Technical change to HDC HE SNAPIN contact inserts

Product Change Notice Number: PCN-PB72-20230220-00-A
Date of publication: 20.02.2023
Validity period: Until revoked
Revision number: 00

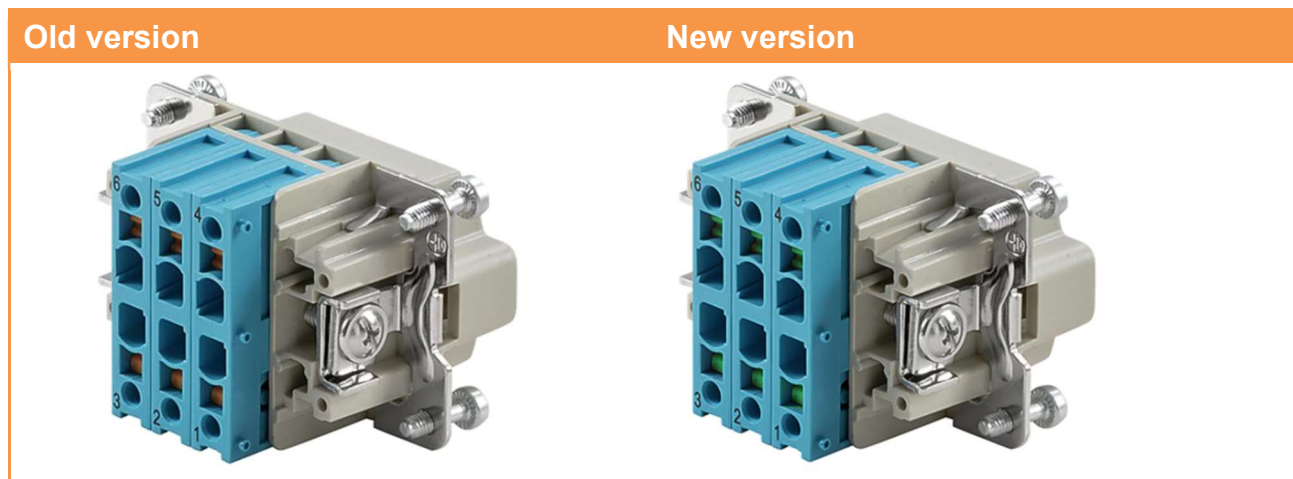
The actuating elements for opening the SNAPIN clamping point were previously in the color orange.

The actuating elements for opening the SNAPIN clamping point will be in the color green in the future.
